STAFF REPORT

RE: 918 Fort Street-AKA 3.2 acres

(project application #TP2022-0019)

FROM: Karen DeMaria, City of Key West Urban Forestry Manager

Tree #2

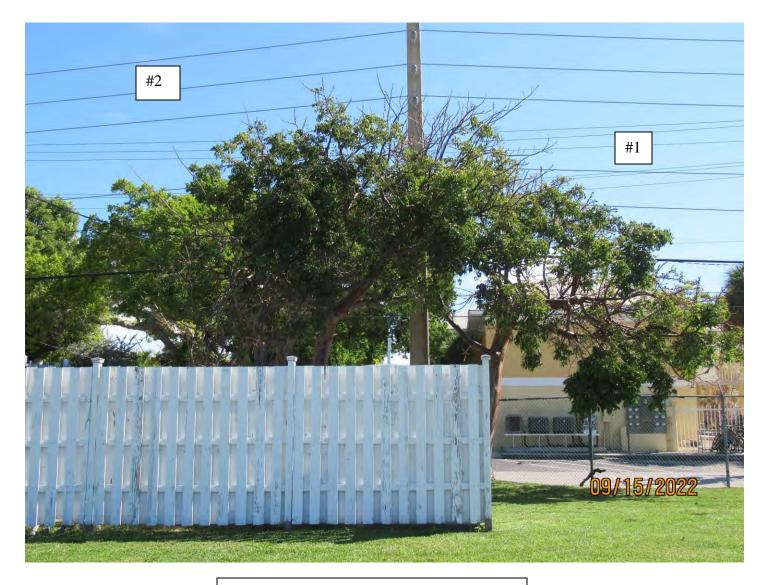
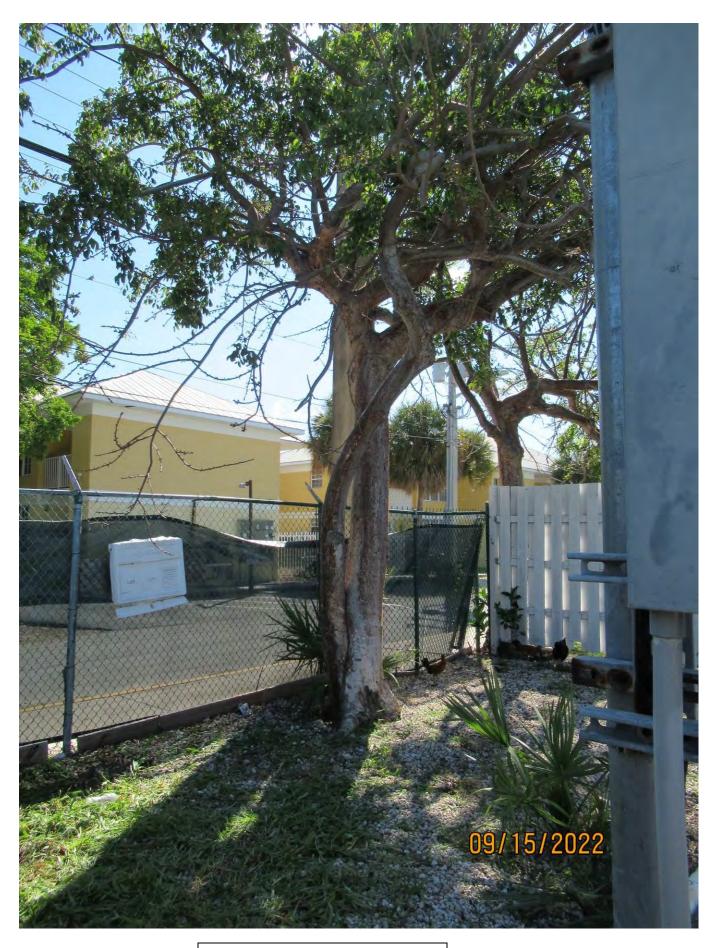
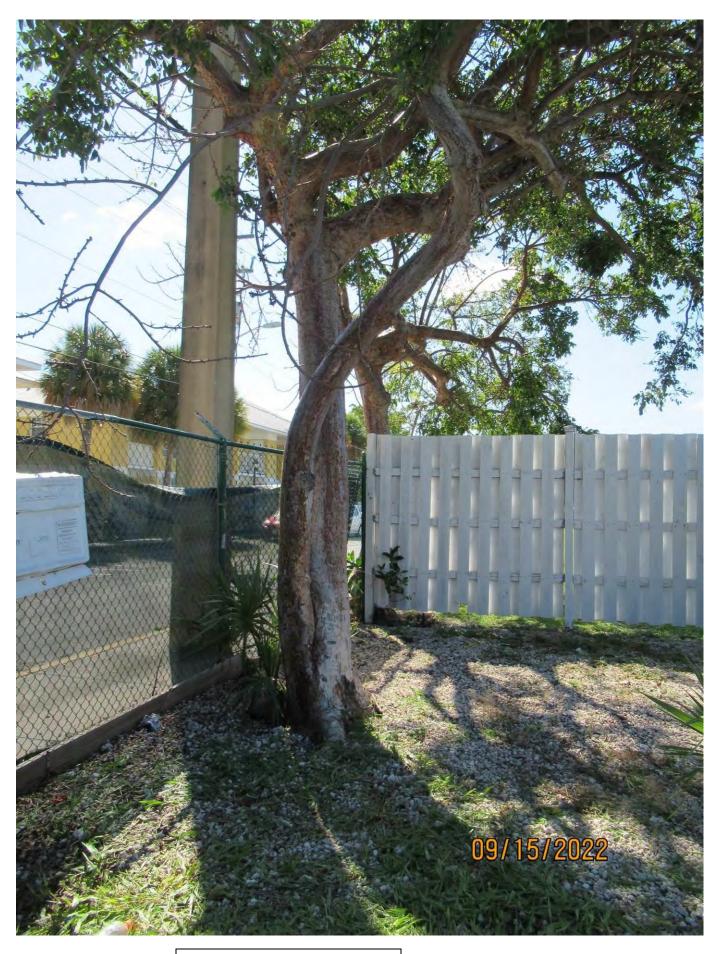
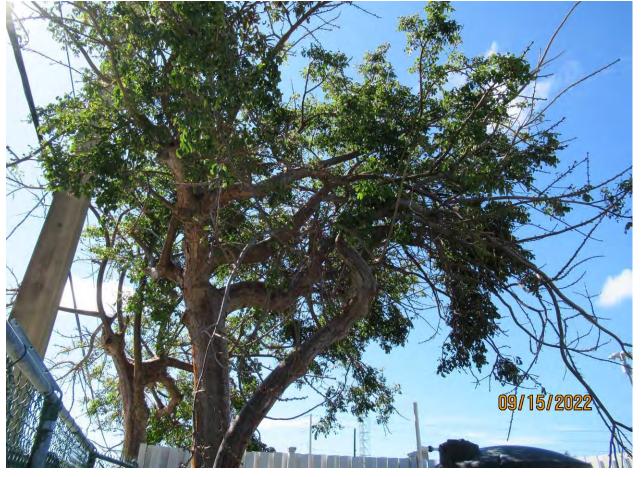
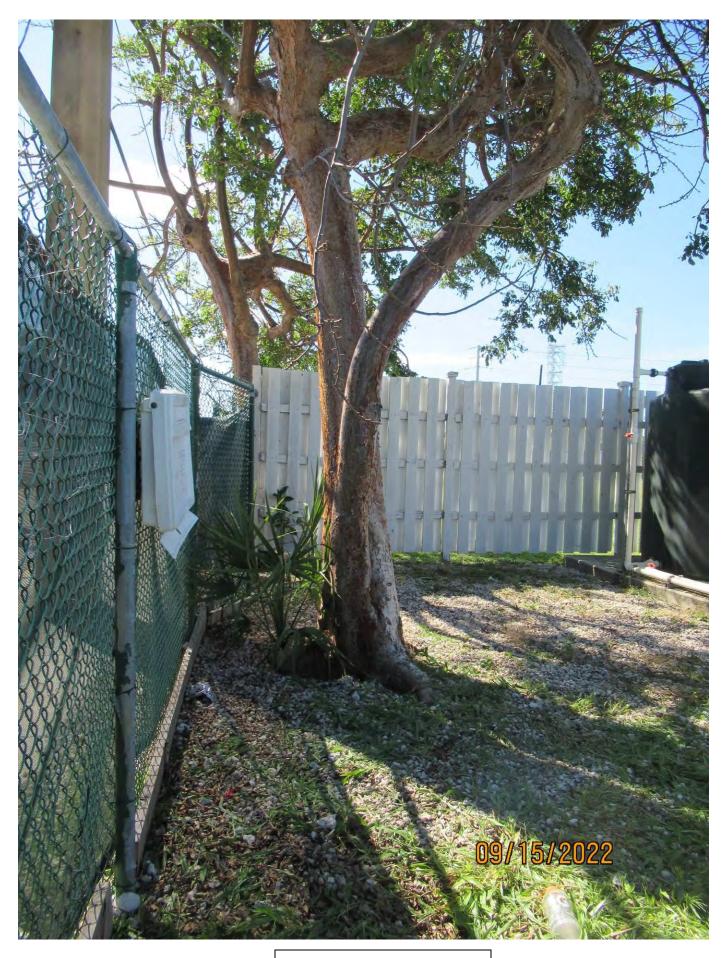
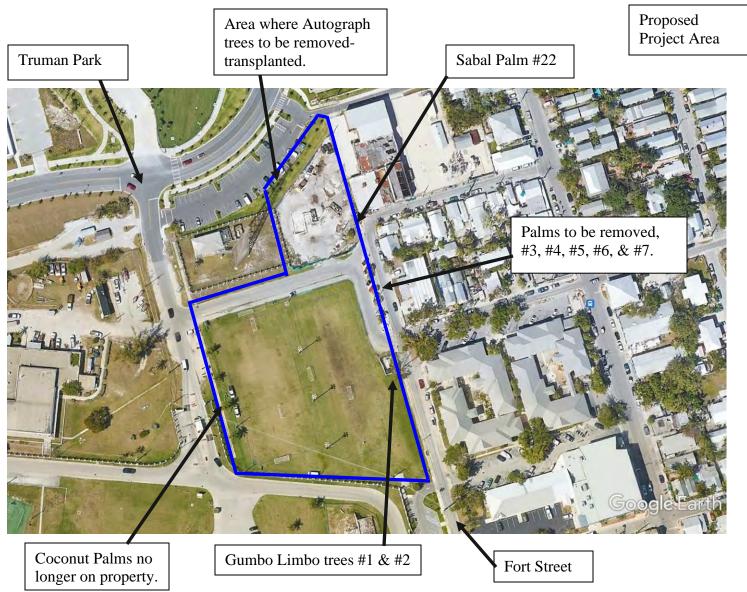
Diameter: 15.2"

Location: 70% (canopy close to utility lines)

Species: 100% (on protected tree list)

Condition: 40% (poor canopy structure, two trunks with included bark.)

Total Average Value = 70%

Value x Diameter = 10.6 replacement caliper inches

Total required replacement if both Gumbo limbo trees removed: 20.2 caliper inches.

- LI TITLE SHEET
- L2 TREE MAP / MITIGATION TABLE
- L3 PLANTING PLAN
- L4 PLANTING PLAN
- L5 OVERALL PROJECT SCHEDULE, PLANT PICTURES
- L6 CODE PLANT SCHEDULES
- L1 CODE PLANT SCHEDULES
- L8 DETAILS AND SPECIFICATIONS

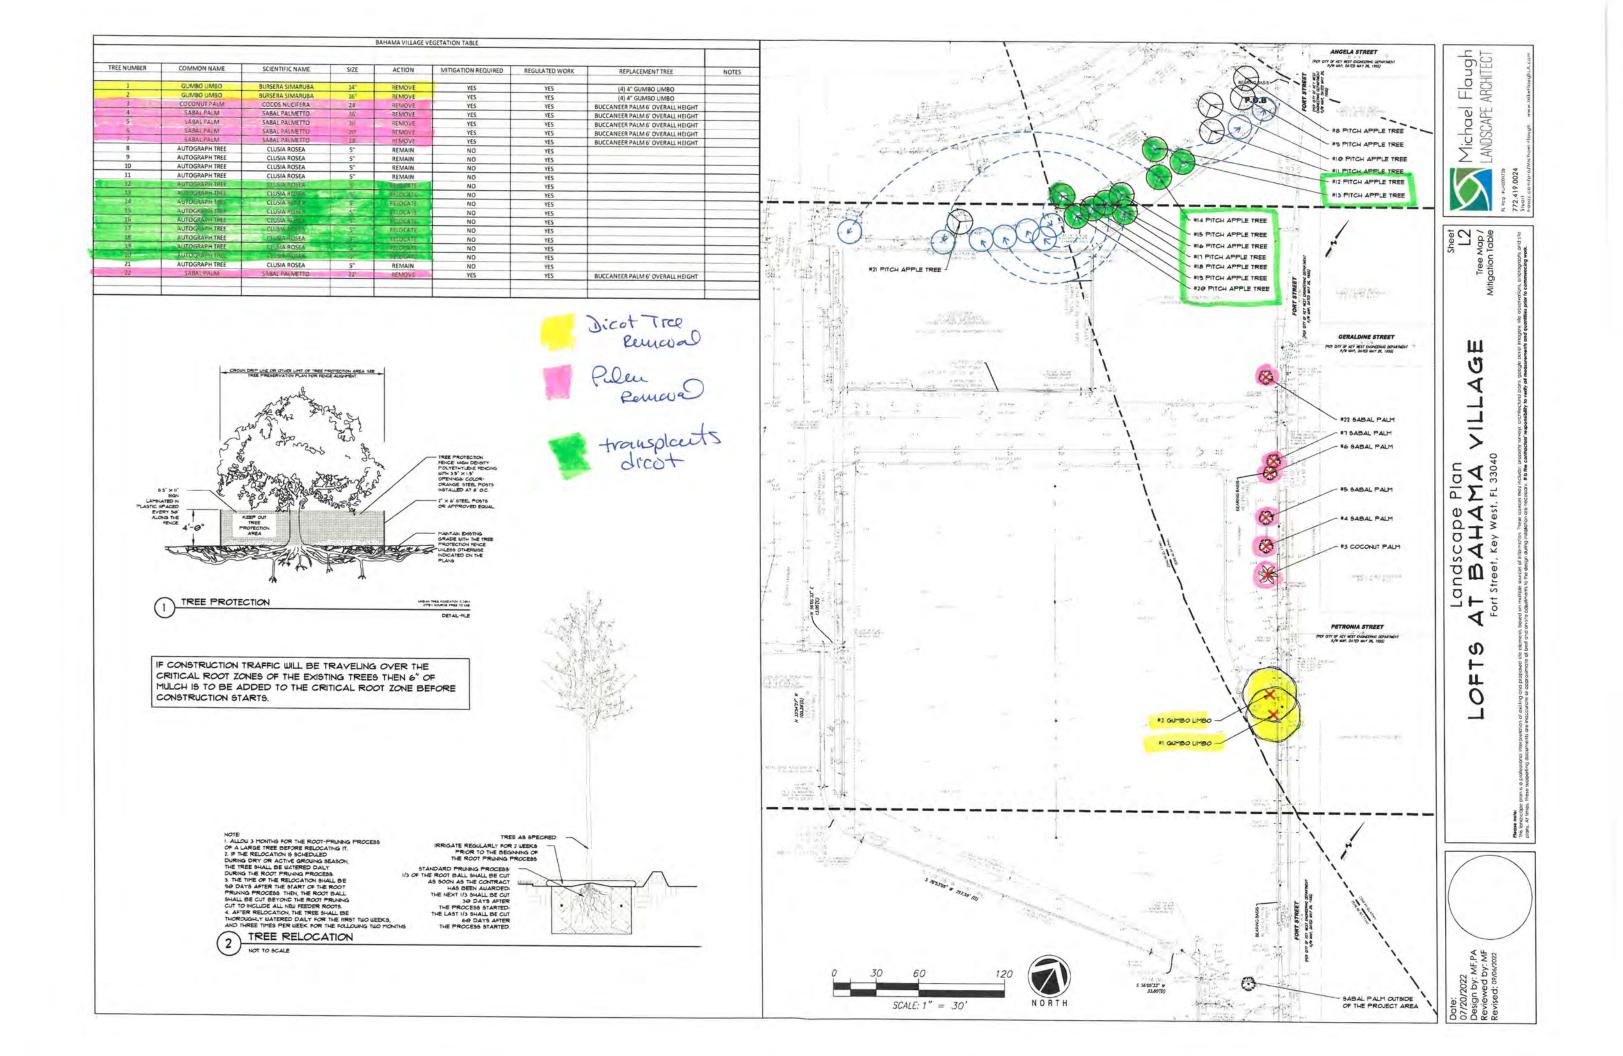
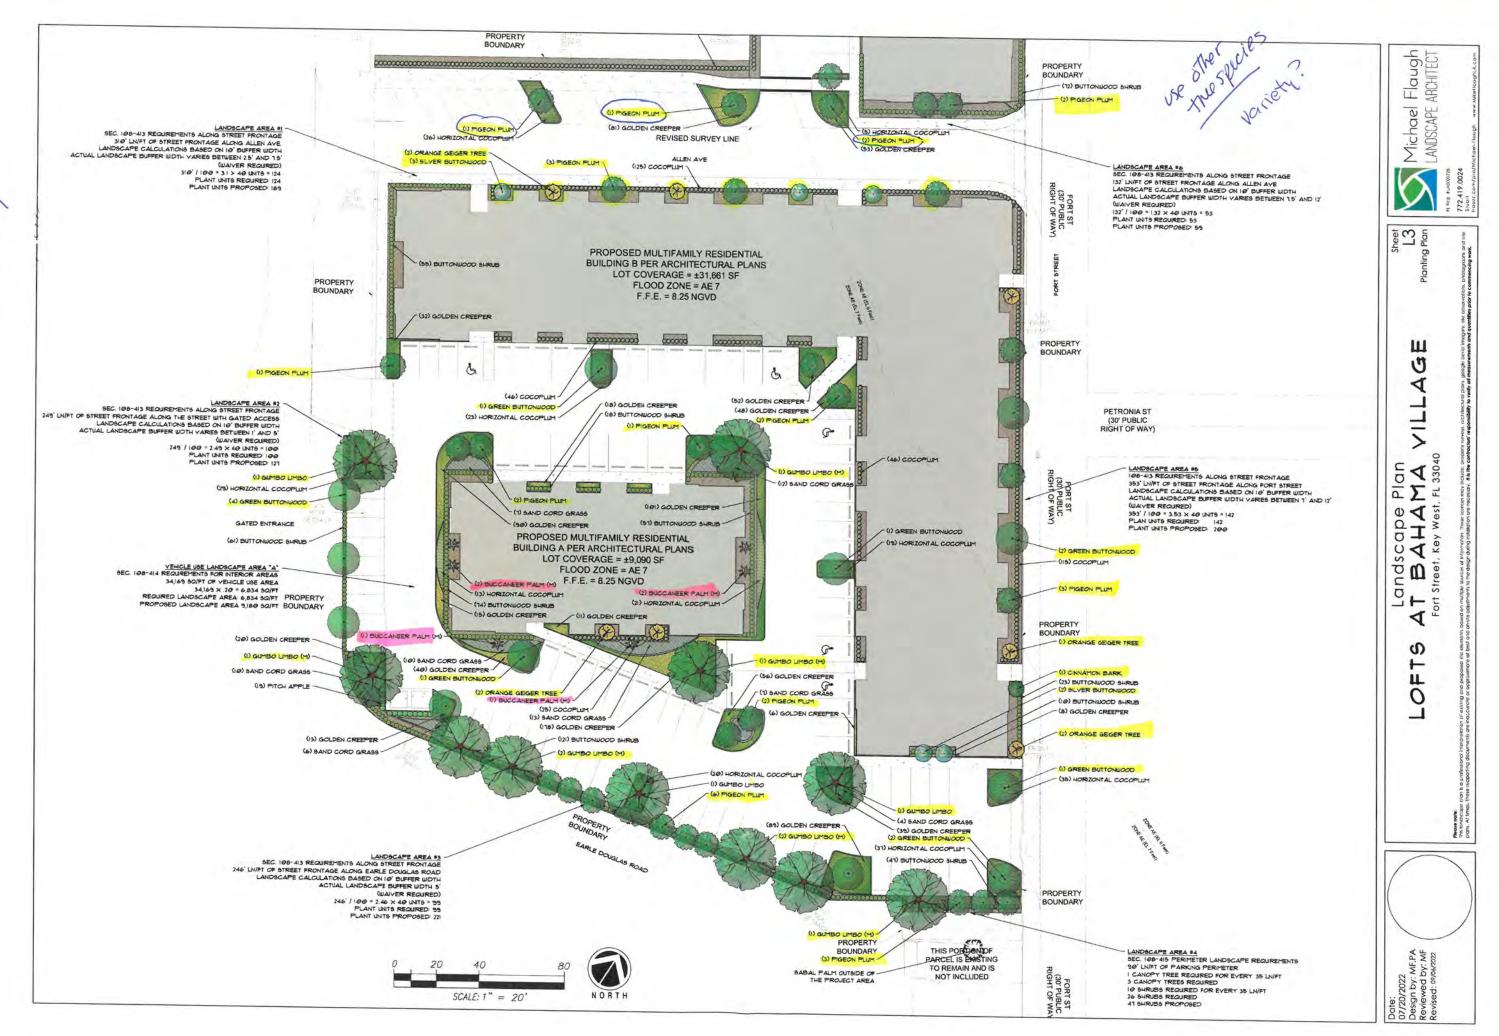
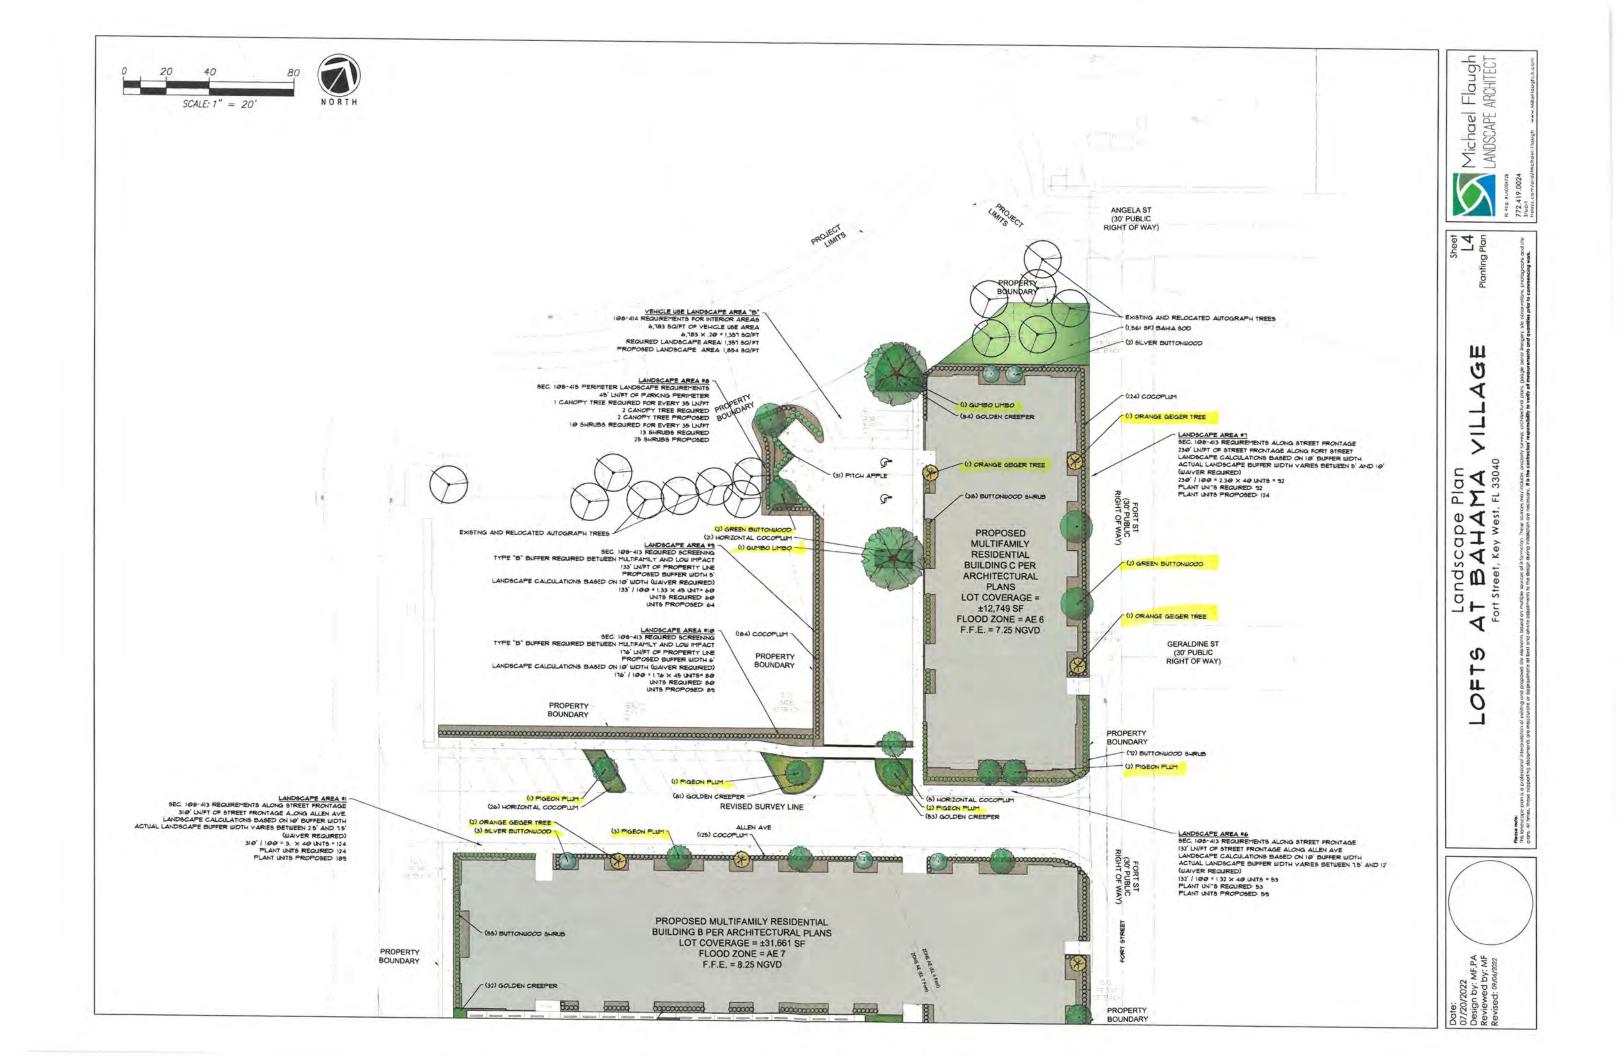
- 1. The relocation of the Autograph trees in the Truman Park parking area for access to proposed development area #1 will need to be coordinated with the Navy and staff. Actual replanting locations are unknown at this time. This work will also require an administrative modification to the Truman Park MDP.

- 2. At least three of the Sabal Palms are eligible for transplanting.
- 3. What is the required Navy buffer from their property line? Based on development requirements with Truman Park, landscaping might not be allowed in certain areas.

- 4. Landscape plan lacks diversity-too many Pigeon plums. Sidewalk and street areas need more canopy type tree species.
- 5. Proposed size of canopy trees in plans is smaller than the ornamental tree sizes. Typical planting of canopy trees in this area should be 65-gallon or a fat 45-gallon sized pot.

- 6. Required mitigation does seem to be included in the landscape plan and the proposed draft plan does include over 70% native vegetation.
